**TB 1-1520-248-30-05**

CHANGE  
NO. 2

**INTERMEDIATE WEIGHT REDUCTION IMPLEMENTATION  
ON OH-58D HELICOPTERS**

### **INTERMEDIATE WEIGHT REDUCTION IMPLEMENTATION ON OH-58D HELICOPTERS**

Figure 15

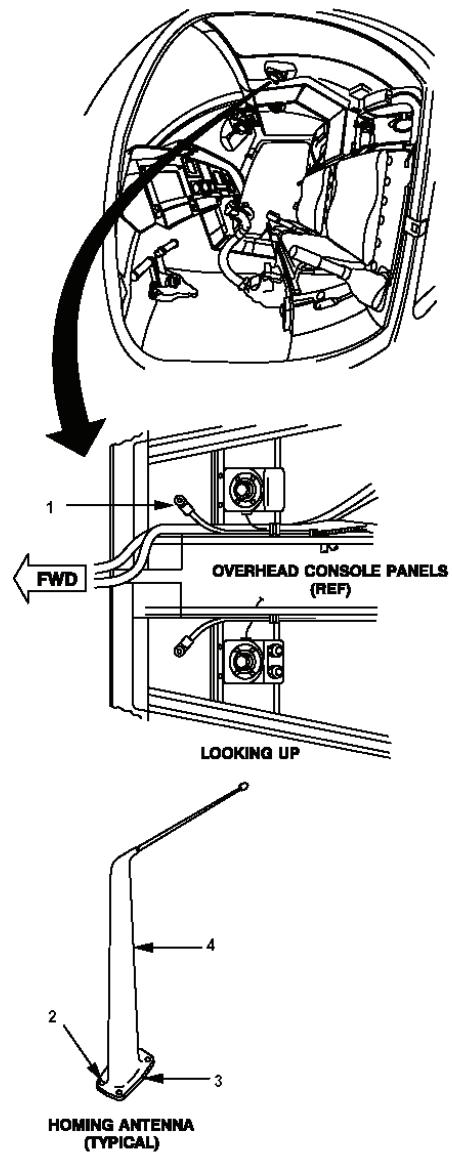
| n. Remove FM Antenna. (See Figure 15)

| (1) Disconnect coax connector (1) for left side.

| (2) Remove old sealing compound from mounting screws (2), mount (3), and surrounding mounting surfaces using plastic scraper.

| (3) Remove four mounting screws (2) from mount (3).

| (4) Remove homing antenna (4).

(5) Fabricate a cover plate from 2024 sheet stock to cover area on roof.

(6) Prime using MIL-PRF-23377 epoxy primer and paint the cover plate.

(7) Apply a layer of sealant, MIL-S-8802, as necessary, to cover plate.

(8) Attach cover plate using screws removed earlier.
